ATTORNEY DOCKET NO. APPLICATION NO FILING DATE FIRST NAMED INVENTOR CONFIRMATION NO. 09/884,522 06/18/2001 Aluizio M. Cruz

Application N	lo.	Applicant(s)		
Office Action Summary		09/884,522		CRUZ, ALUIZIO M.		
		Examiner		Art Unit		
		Akm Enayet U	Jllah	2874		
The MAILING DATE of this communication appears on the cover sheet with the correspondence address						
Period for Reply						
A SHORTENED STATUTORY PERIOD FOR REPLY IS SET TO EXPIRE 3 MONTH(S) FROM THE MAILING DATE OF THIS COMMUNICATION. - Extensions of time may be available under the provisions of 37 CFR 1.136(a). In no event, however, may a reply be timely filed after SIX (6) MONTHS from the mailing date of this communication. - If the period for reply specified above is less than thirty (30) days, a reply within the statutory minimum of thirty (30) days will be considered timely. - If NO period for reply is specified above, the maximum statutory period will apply and will expire SIX (6) MONTHS from the mailing date of this communication. - Failure to reply within the set or extended period for reply will, by statute, cause the application to become ABANDONED (35 U.S.C. § 133). - Any reply received by the Office later tha

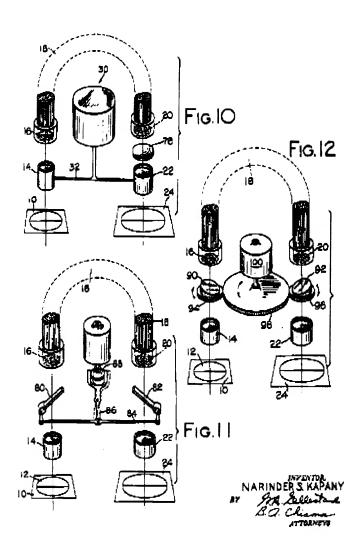
Claims 1-3,7 and 22 are also rejected under 35 U.S.C. 102(b) as being anticipated by Kapany (USPNO. 3,016,785).

The figure 10-12 of Kapany reference is also clearly teaches the instant invention, as claimed.
